**PLANNED UNIT DEVELOPMENT
& SUBDIVISION STAFF REPORT****Date: April 3, 2008**

DEVELOPMENT NAME Dobbs Industrial Park Subdivision, First Addition,
Resubdivision of Lots 1 & 2

CONTEMPLATED USE Planned Unit Development Approval to allow two
buildings on a single building site.

SITE PLAN

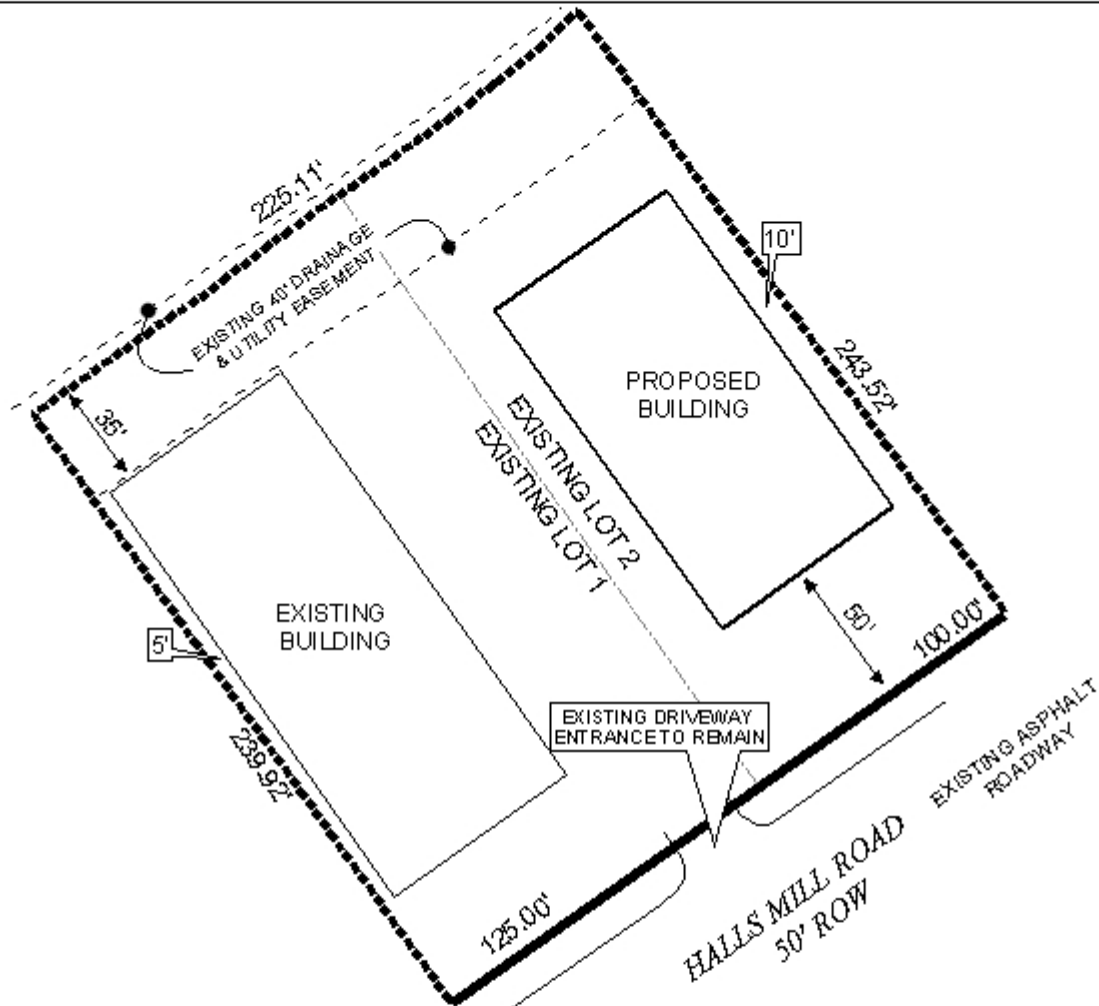
Regarding the PUD, the site plan submitted indicates an existing sheet metal and guttering fabrication building and a proposed second building for the site. No narrative was submitted giving a detailed description of use for the proposed building or time table for expansion. The site plan submitted indicates all property line setbacks to be compliant, and site coverage is determined to be compliant graphically, however, no site coverage calculations are given. No internal circulation or parking is indicated, and no indication of truck loading/unloading, if any, is indicated. Only the existing curb cut to Halls Mill Road is shown to remain. There are no parking calculations provided based on internal square footage uses of the buildings, warehouse employees, etc., and no landscaping areas and tree plantings are shown or calculations provided. No storm water detention area is indicated, but no verification is furnished that such would not be required. No dumpster is depicted on the site plan. If a dumpster is proposed, it should be depicted on the site plan, or a statement should be provided indicating that no dumpster will be included as part of the development. The site plan is based on the current recorded lots with a 50' right-of-way for Halls Mill Road and does not take into consideration any impact of the required dedication. All site improvements would have to be situated out of any required frontage dedication.

- 1) inclusion of a narrative giving a detailed description of the use of the proposed building and a timetable for expansion;
- 2) inclusion of calculations for site coverage, parking ratios based on internal uses of buildings, and for landscaping and trees;
- 3) depiction of parking, internal circulation, dumpster location (if any), truck loading/unloading (if any), and storm water detention (if any); and
- 4) revision of the site plan to indicate all improvements based on required frontage dedication.

- 1) insufficient information is provided to determine if any required on-site parking and maneuvering areas would be within the dedicated frontage right-of-way, thereby creating a violation of the Zoning Ordinance; and
- 2) insufficient information is provided to determine if the site can accommodate all improvements planned and required, potentially creating a violation of the Zoning Ordinance.

- 1) no narrative was furnished giving a detailed use of the proposed building and a timetable for expansion;
- 2) no calculations were furnished for site coverage, parking ratios based on internal uses of buildings, or for landscaping and trees;
- 3) the site plan was not revised to depict parking, internal circulation, dumpster location (if any), truck loading/unloading (if any), and storm water detention (if any); and
- 4) the site plan was not revised to indicate all improvements based on required frontage dedication.
